Access Compliance Report

Public Rights-of-Way

(Curb Ramps)

Intersection ID: 23859	Main Street: SOUTH_BV	Cross Street: LONGLEAF_DR	Location: SE
ADA ID: D35E6D7EED12	Ramp Type: PerpDiag	Initial Pass/Fail: Fail	Overall Compliance: No
Severity Score: 33.75			
Codes/Mitigation Info/Possible Solution		Field Measurements/Component Compliance

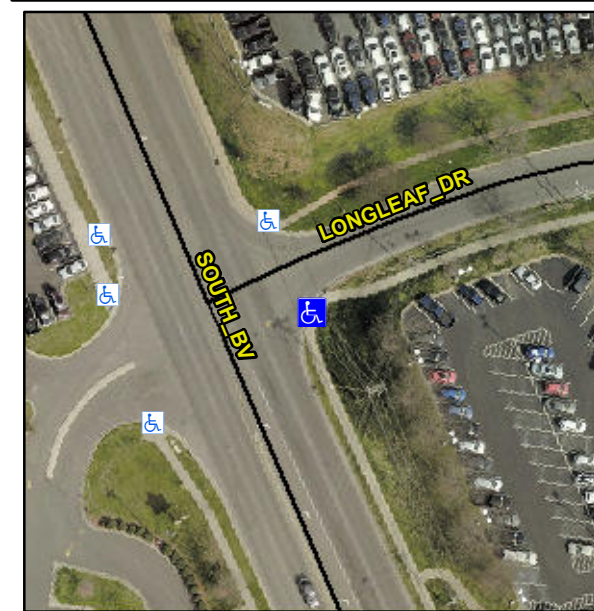
Not Found, R304.5.1, R304.5.3

Compliance	Description	Data	Compliance	Description	Data
N/A	Ramp Length (in)	60.0	Yes	Ramp Slope (%)	6.2
No	Ramp Width (in)	44.0	No	Ramp XSlope (%)	7.3
N/A	Flare Type LT	N/A	N/A	Flare Type RT	N/A
N/A	Flare Slope LT (%)	N/A	N/A	Flare Slope RT (%)	N/A
N/A	Flare Traversable LT?	N/A	N/A	Flare Traversable RT?	N/A
N/A	Landing Length (in)	N/A	N/A	DWS Provided?	N/A
N/A	Landing Width (in)	N/A	N/A	DWS Contrast?	N/A
N/A	Landing Slope (%)	N/A	N/A	DWS Length (in)	N/A
N/A	Landing X Slope (%)	N/A	N/A	DWS Full Width?	N/A
N/A	Landing Curb? (Y/N)	N/A	N/A	DWS Offset (in)	N/A
N/A	Shared Landing?	N/A			
N/A	Gutter Ponding?	N/A	N/A	Gutter Slope (%)	N/A
N/A	Gutter Lip Ht (in)	N/A	N/A	Gutter X Slope (%)	N/A
N/A	Painted X Walk1?	No	N/A	Painted X Walk2?	No
	X Walk 1 Direction	To N		X Walk 2 Direction	To W
N/A	X Walk 1 Width (in)	N/A	N/A	X Walk 2 Width (in)	N/A
	X Walk 1 Slope (%)	6.9		X Walk 2 Slope (%)	1.6
	X Walk 1 X Slope (%)	1.9		X Walk 2 X Slope (%)	8.3

N/A	Ramp inside XWalk1?	N/A	N/A	Ramp inside XWalk2?	N/A
	Road Slope (%)	5.5	N/A	Clear Space?	N/A
	Road X Slope (%)	7.7	N/A	Clear Space to XWalk (in)	N/A
N/A	Any Obstructions?	N/A	N/A	Storm Grate/Utility Hazard?	N/A
	Obstruction Type			Storm Grate/Utility Type	
		N/A			N/A
		Yes		Surface Condition? (G/P)	Good

Remove & Replace Curb Ramp With Two New Directional Ramps or Equivalent.
